PD Modification Application: MM 22-0689
Zoning Hearing Master Date: May 15, 2023 (2nd REMAND)
BOCC CPA Meeting Date: August 10, 2023

APPLICATION NUMBER: MM 22-0689

Case Reviewer: Michelle Heinrich, AICP

Figure 1: Proposed Site Plan Changes

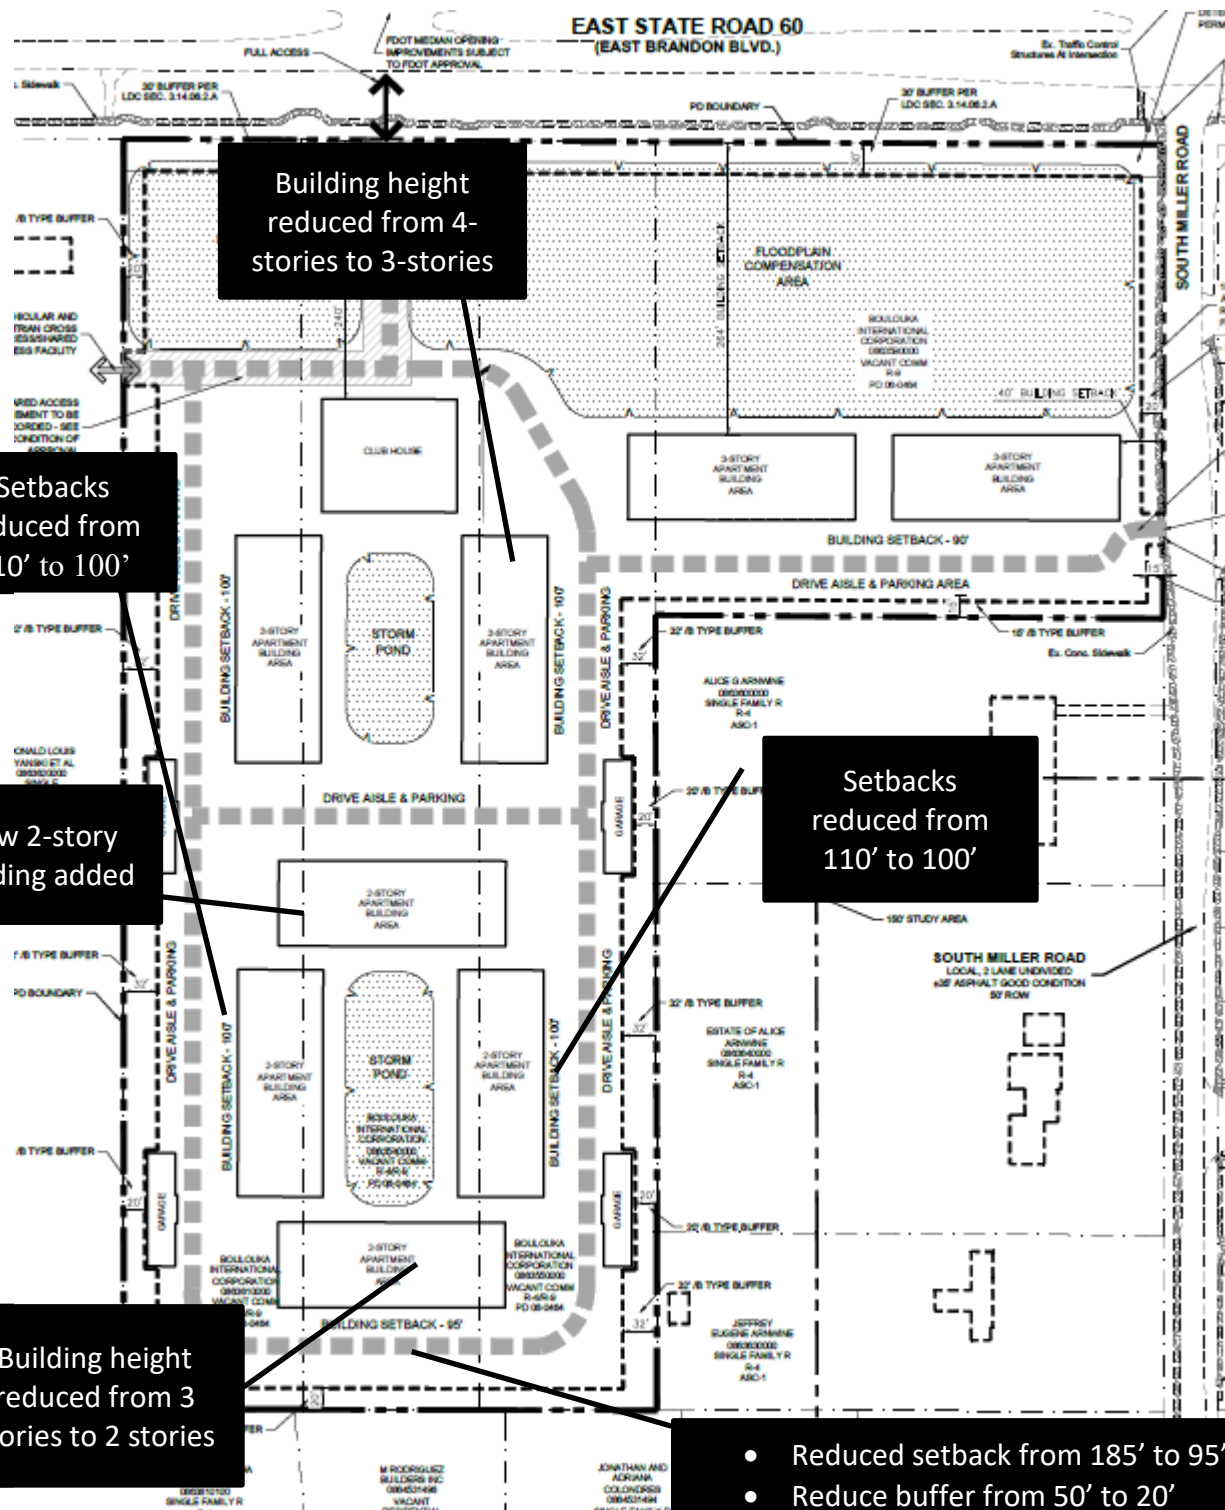
Building height reduced from 4-stories to 3-stories

New 2-story building added

Building height reduced from 3 stories to 2 stories

- Reduced setback from 185' to 95'
- Reduce buffer from 50' to 20'
- Shift drive aisle and parking southward

Figure 2: Proposed Building Heights and Buffering and Screening

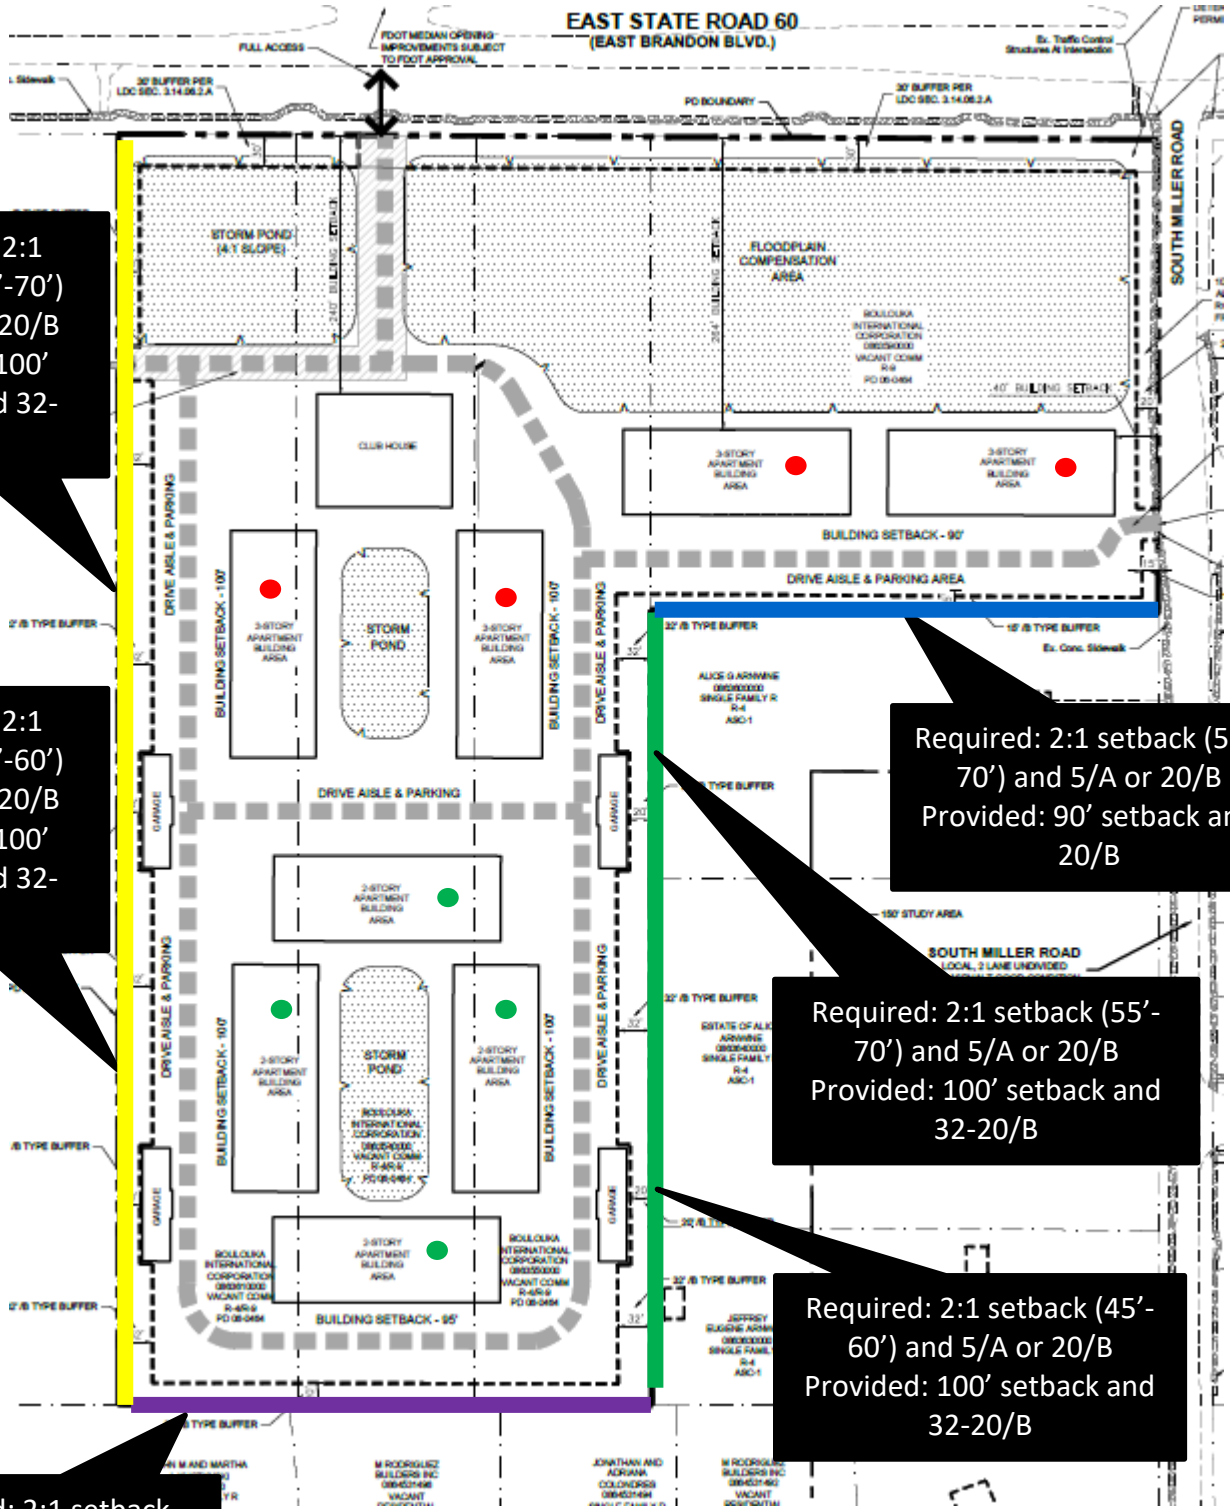
Required: 2:1 setback (55'-70') and 5/A or 20/B
 Provided: 100' setback and 32-20/B

- 2-stories/40 ft
- 3-stories/45 ft

8.2 Proposed Site Plan (Full)

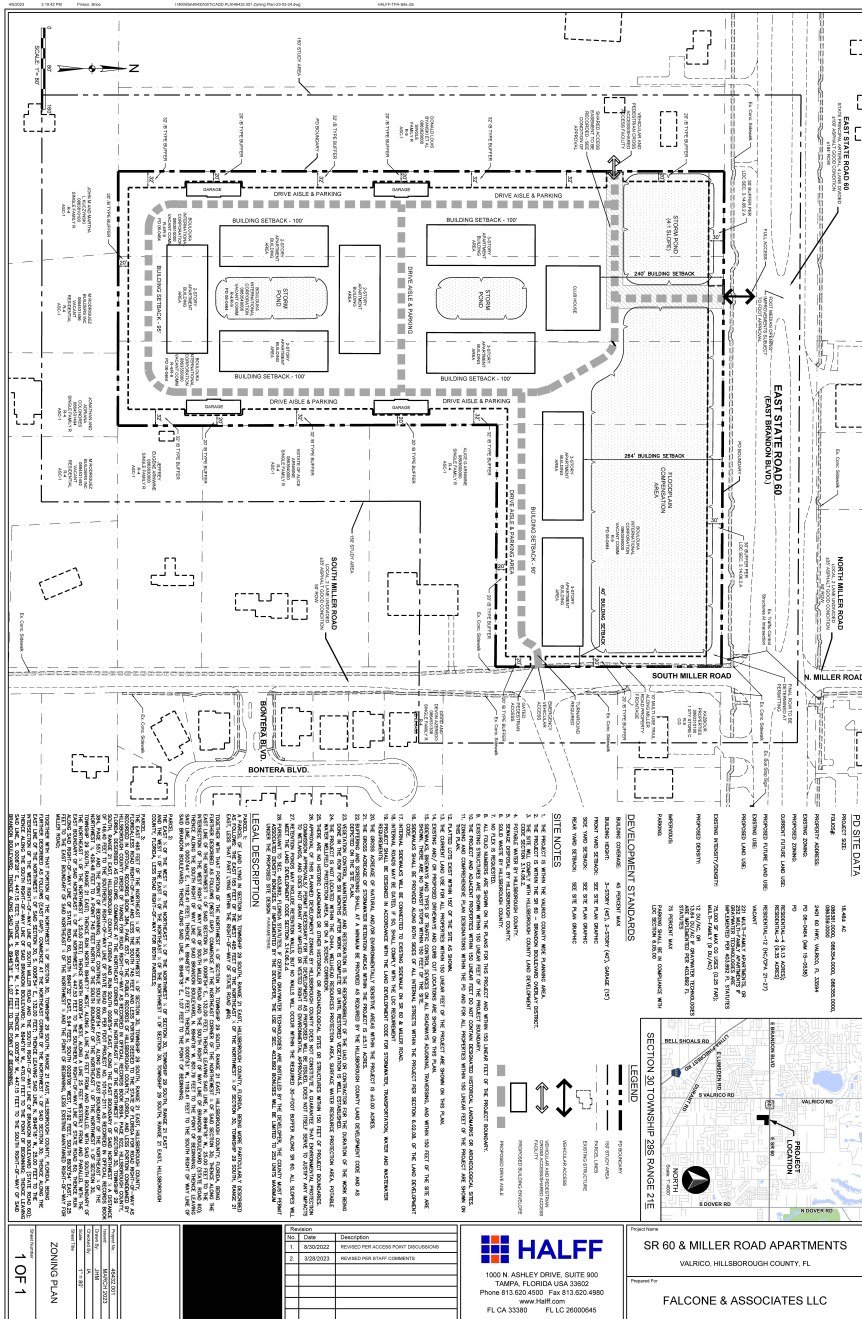
- Converted three southern apartment buildings from 3-story to 2-story buildings to provide better transition to single family residential to the south;

- Added a fourth 2-story building;
- Reduced building setback for southern building from 185 feet to 95 feet due to significant reduction in height to 2 stories;

- Shifted parking/drive aisle south to make up for additional building;
- Reduced southern buffer from 50-feet to 20-feet to make up for the shifted parking/drive aisle due to change in height from 4 stories to 2 stories;

- Reduced eastern/western building setbacks from 110-feet to 100-feet due to change in building height and density;
- Reduced buffer from 20-feet to 15-feet on the southern edge discharging to Miller Road; and

In response to the BOCC's request to re-examine the proposed full access connection on S. Miller Road, the applicant submitted a revised site plan proposing to change the access connection to S. Miller Rd. to a gated emergency access with a pedestrian connection and change the restricted right-in/right-out/left-in access connection on SR 60 to a full access connection. To support the proposed change the applicant submitted a revised site access analysis and reviewed the proposed changes with FDOT staff.

4. Multi-Family building heights shall be limited to a maximum of 58 feet/4-stories or 45 feet/3-stories. Garage building heights shall be limited to a maximum of 15 feet.

5. Buffering at the widths depicted on the general site plan along the western, southern and eastern PD boundaries shall be provided. Type B screening shall be provided within these buffers as specified in conditions ~~1918.1, 1918.2 1918.3, 1918.4 and 1918.5.~~ As depicted on the general site plan, the sidewalk/multi-purpose path along South Miller Road shall be permitted to encroach into the required buffer along South Miller Road.

The project shall be permitted one ~~restricted right-in/left-in/right-out~~ full access connection on SR 60, subject to FDOT approval, and one ~~full access~~ gated emergency access with pedestrian connection onto S. Miller Road.

9.1. The developer shall construct a 10-foot sidewalk along the project frontage on S. Miller Rd., as shown on the PD site plan.
